Site Plan and Design Review Staff Report and Recommendation

REPORT DATE:	June 12, 2017
HEARING DATE:	June 19, 2017
LAND USE REQUEST:	Site plan approval and design review of Stonewood Center, a proposed commercial and office complex consisting of four buildings totaling 45,280-square-feet, a restaurant with drive-through, parking and landscaping
FILE NUMBER:	311-16-000197-PLNG
PROPERTY LOCATION:	3650 Pacific Avenue
LEGAL DESCRIPTION:	Washington County Tax Lots 1S305AB00501 & 1S305AB00504
OWNER/APPLICANT(S):	<u>Applicant/Property Owner:</u> A. C. "Buzz" Avery, 27752 County Lane, Laguna Niguel, CA 92677 <u>Applicant's Representatives:</u> • Barry Newdelman Associates Architects, 2340 SE Tamarack Avenue, Portland, Oregon 97214 • Jeff Bolden, Multi-Tech Engineering Inc., 1155 13th Street SE, Salem, Oregon 97302
COMPREHENSIVE PLAN MAP AND ZONING MAP DESIGNATIONS:	Community Commercial (CC) Community Commercial (CC)
APPLICABLE STANDARDS AND CRITERIA:	City of Forest Grove Development Code ☐ §10.3.300 - .340 <i>Commercial and Mixed Use Zones</i> ☐ §10.7.200 et. seq. <i>Solid Waste and Recycling</i> ☐ §10.8.000 et. seq. <i>General Development Standards</i> City of Forest Grove Design Guideli

NORTH ELEVATION
COLOR SK-A

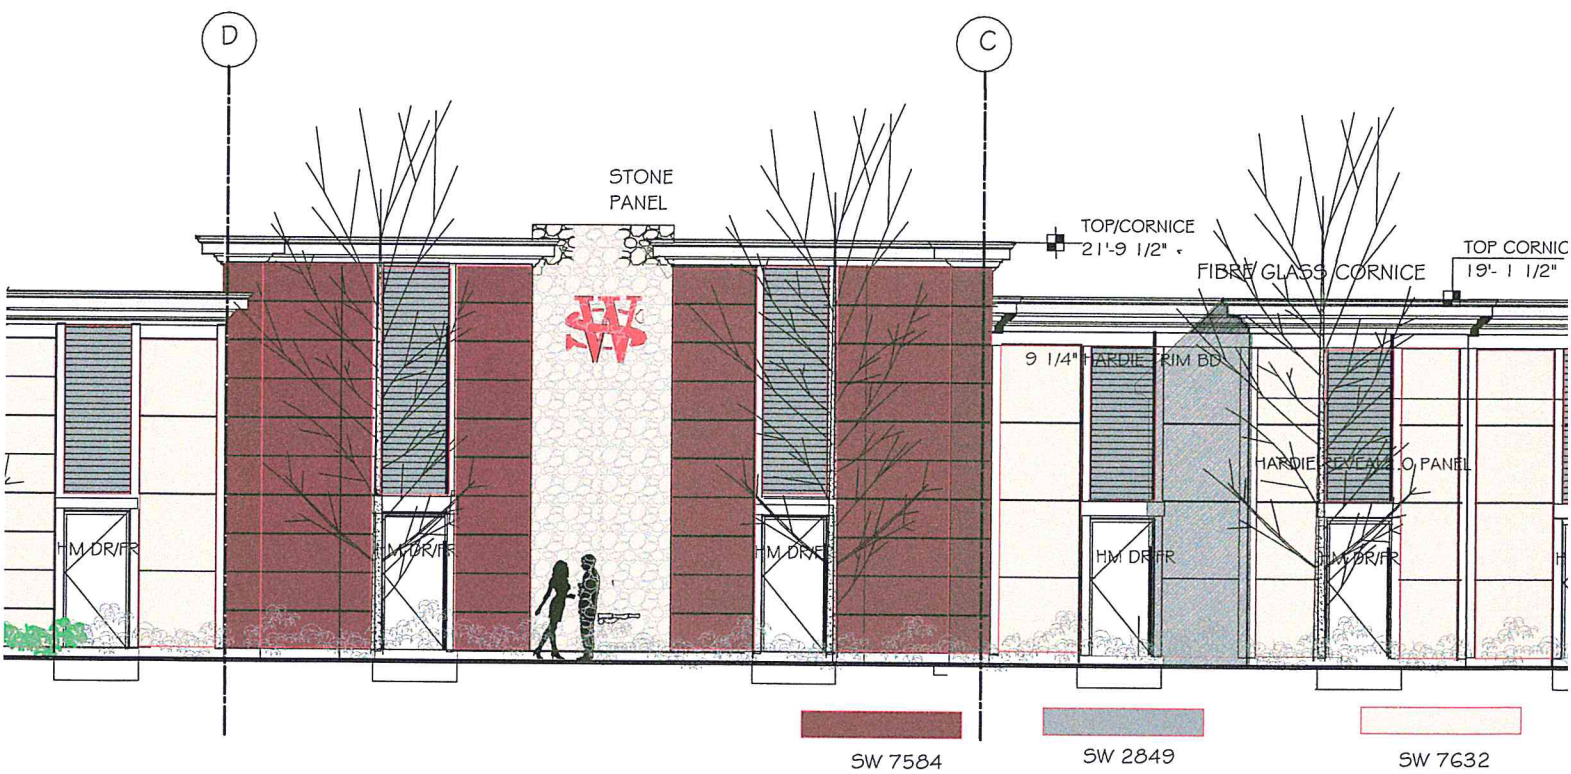
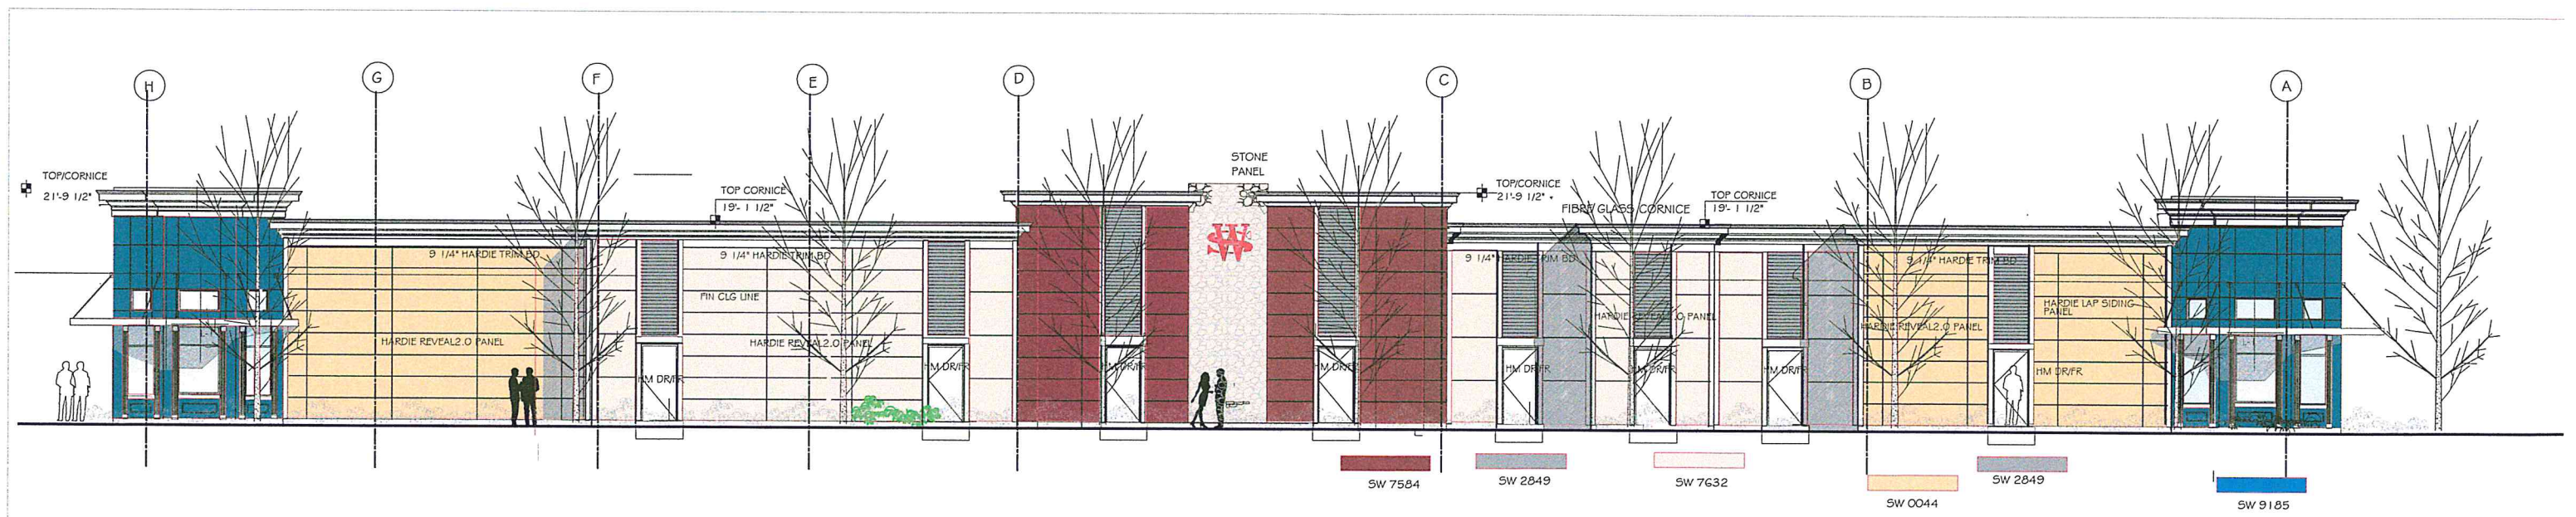
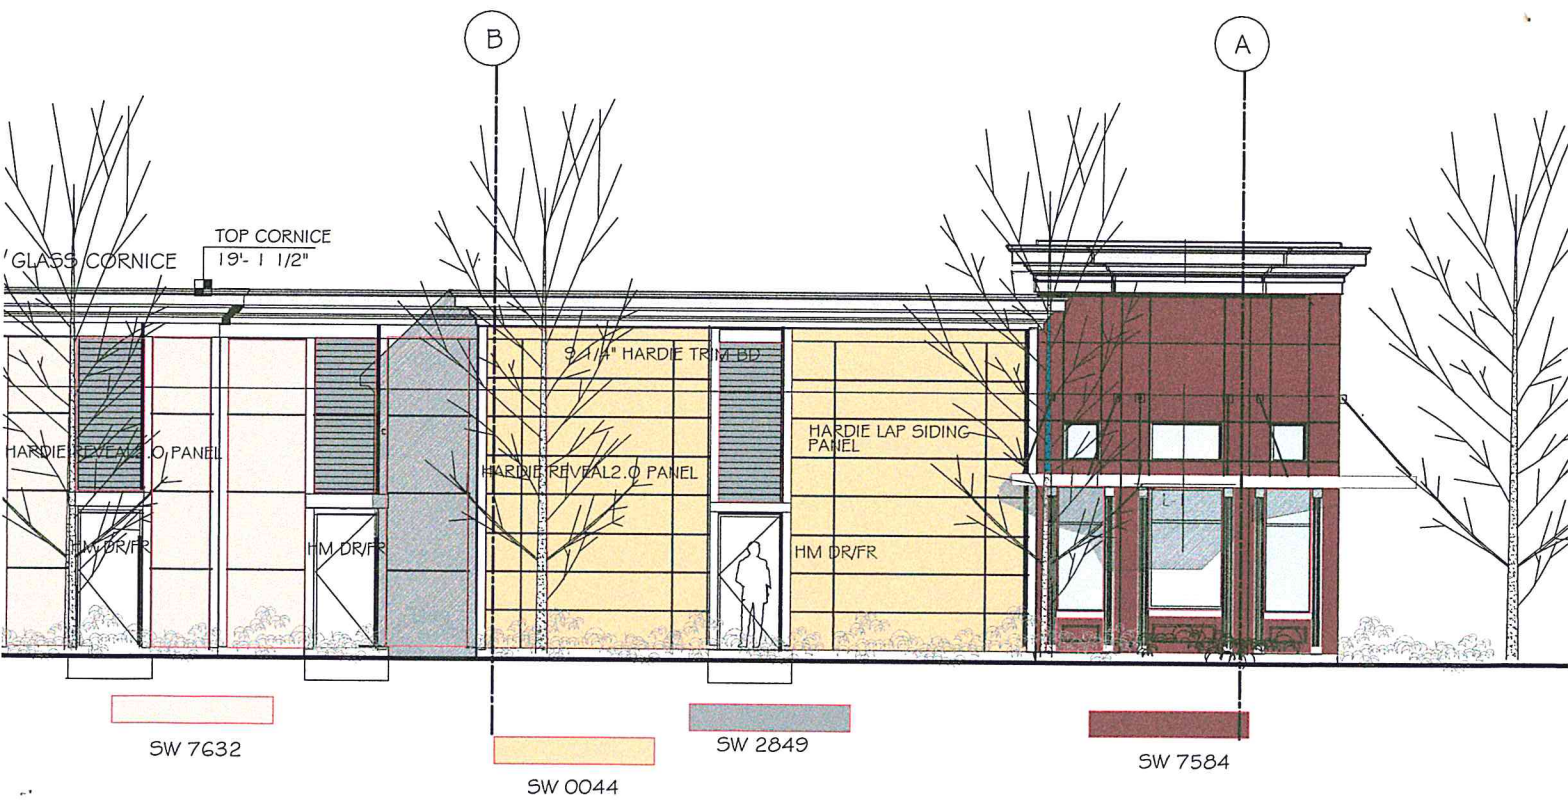
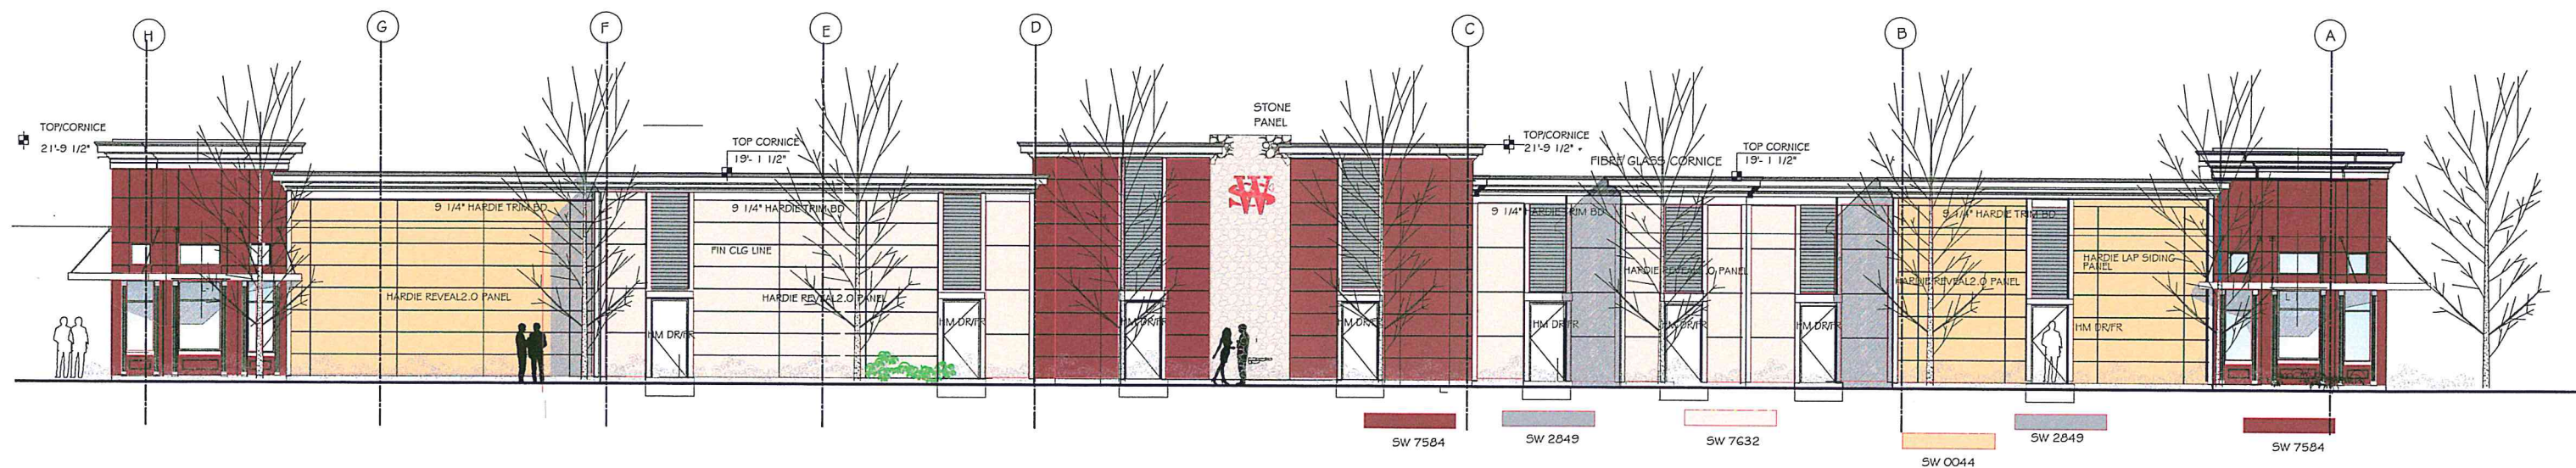
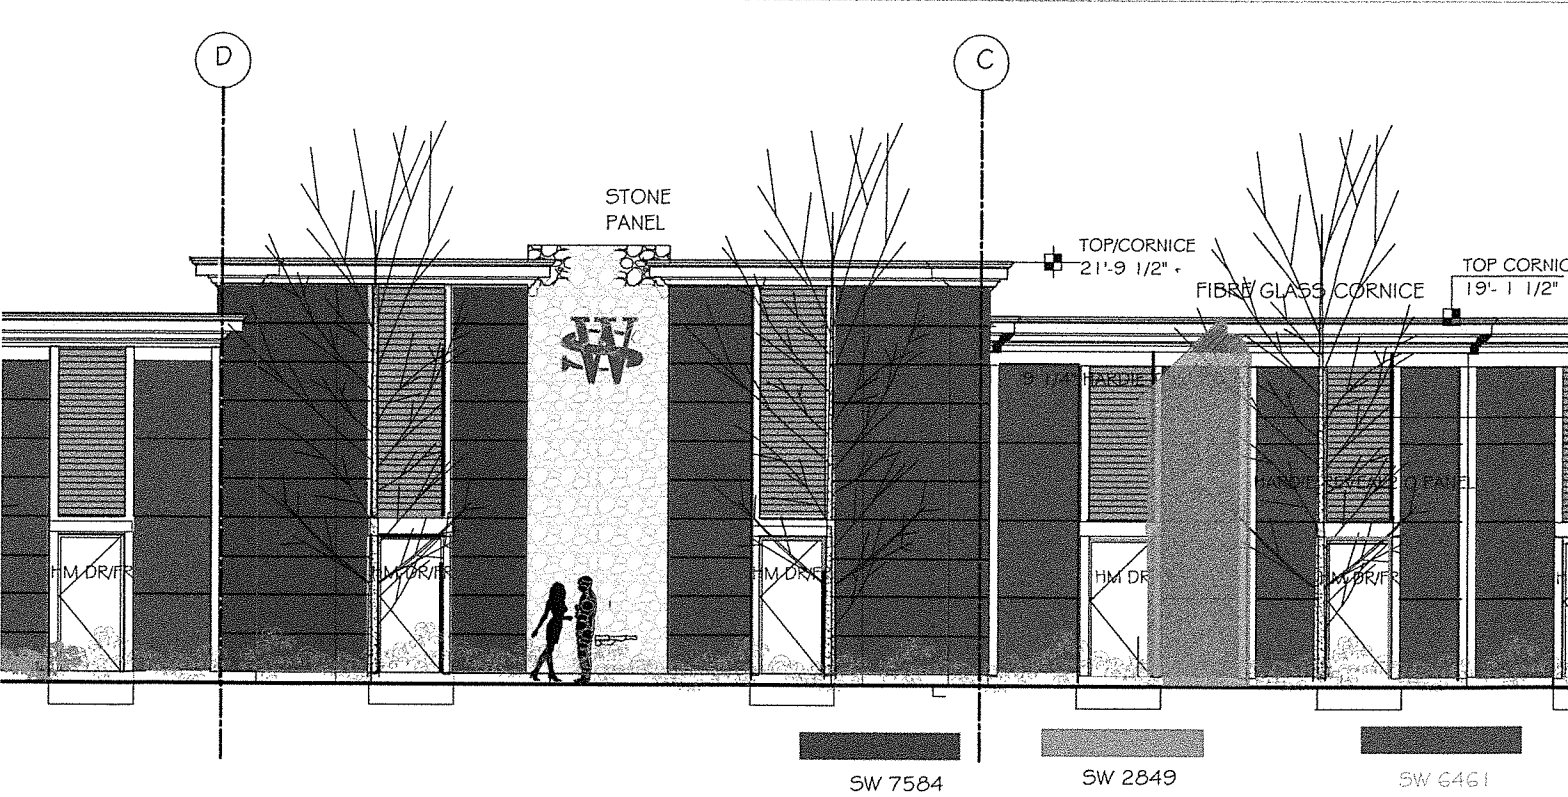
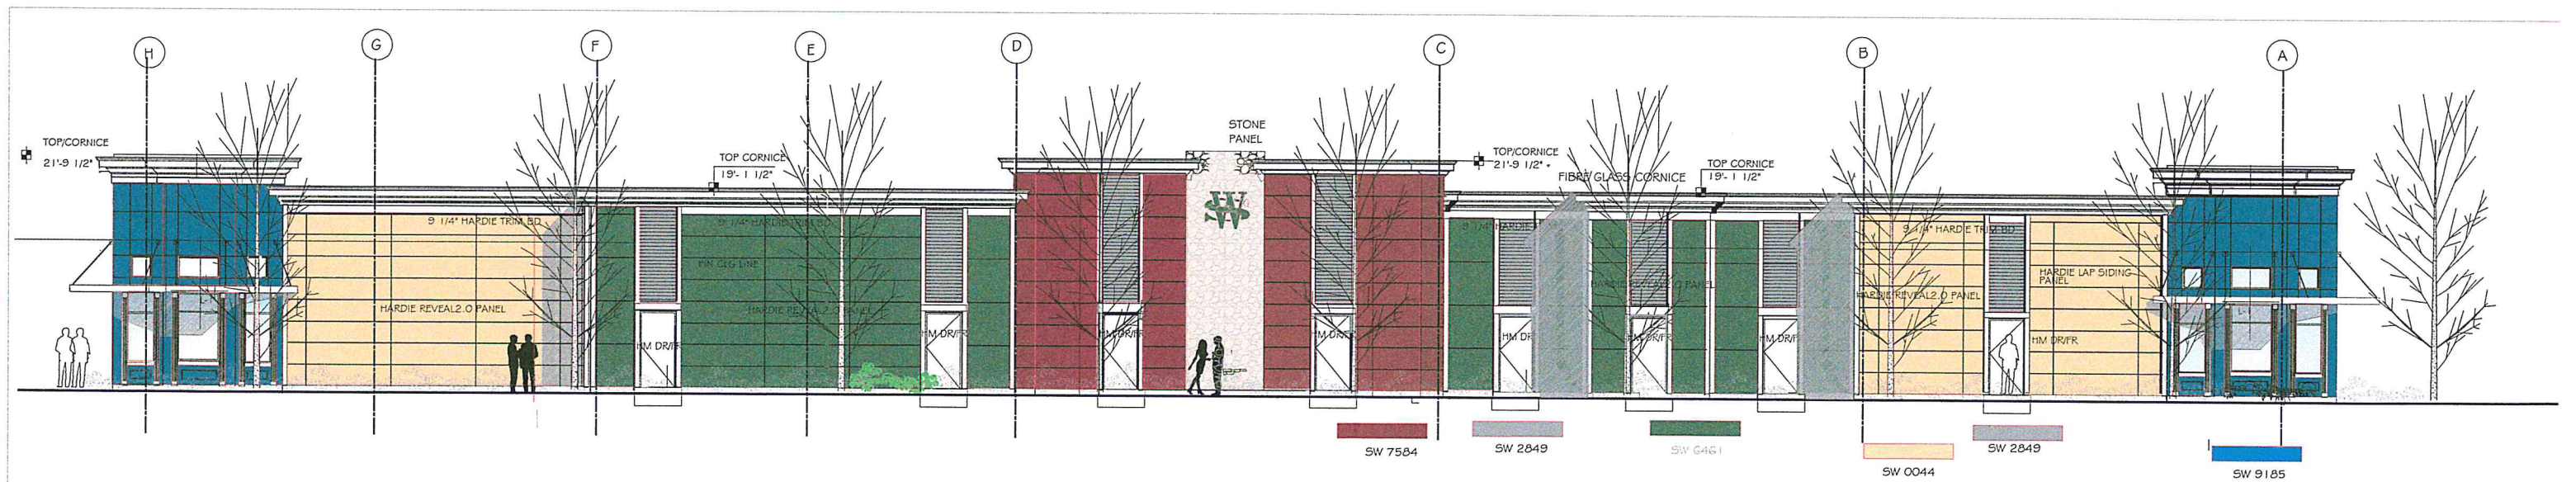
2. Revisions to Building 1 to provide architectural enhancements along the Pacific Avenue façade: Proposed siding materials include HardiePanel, HardiePlank Lap Siding, and stone panel veneers. The HardiePanel siding can be specified in smooth or stucco finish and can be pre-painted in one of 25 colors, or custom painted. HardiePlank Lap Siding has a variety of finishes including smooth, beaded smooth, and colonial smooth, in addition to the rough-sawn or faux wood grain finish frequently seen in residential applications. It too can be pre-painted in one of 25 colors, or custom-painted. Further detailing would be provided through the use of reveals, trim boards and color (see Exhibit C).

Staff concludes that the number of materials combined with the number of potential finishes and colors would provide sufficient architectural detailing. Staff would recommend that the Commission either:

- a. Provide **direction** on the three color schemes provided, either by selecting one option or a modification to the options provided; or
 - b. Add a **condition** for the Director to approve the particular color scheme prior to approval of the building permit.
